## **UDPRP Review Summary 05.22.15**

PROJECT: Alamo Manhattan\_Bishop Arts Gateway

## Alamo Manhattan\_Bishop Arts

SITE PLAN

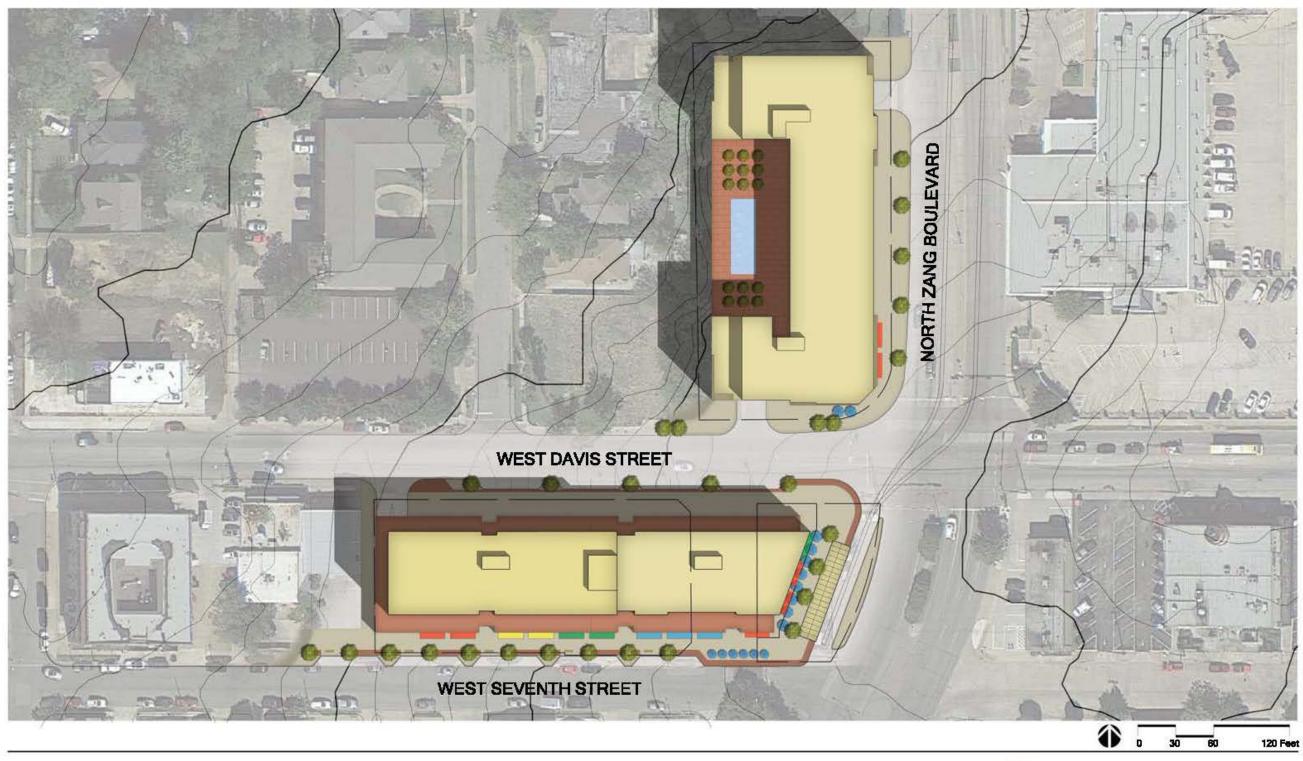
- [1] Consider adjusting individual building masses to help mitigate the proposed development scale and better integrate into the existing neighborhood character, particularly along the western portions of the project site.

- [2] Explore modifying the proposed program to allow for the flexibility to employ architectural responses that help unite the project with the surrounding context.

- [3] The panel recommends minimizing the variations in sidewalk elevation along 7<sup>th</sup> street, resolving a portion of the changes in grade inside the building envelope rather than in the public realm.

- [4] Carefully consider the allocation of space in the proposed 7<sup>th</sup> street section, particularly the travel lanes, in an effort to highlight its pedestrian nature.

- [5] The panel recommends the City engage the appropriate decision making bodies to ensure a high level of integration of the street car stop into the overall pedestrian realm.

- [6] The panel recommends that the City develops a strategy that looks at the larger neighborhood in anticipation of future development to proactively address foreseeable issues of integrating higher density development into the existing neighborhood.
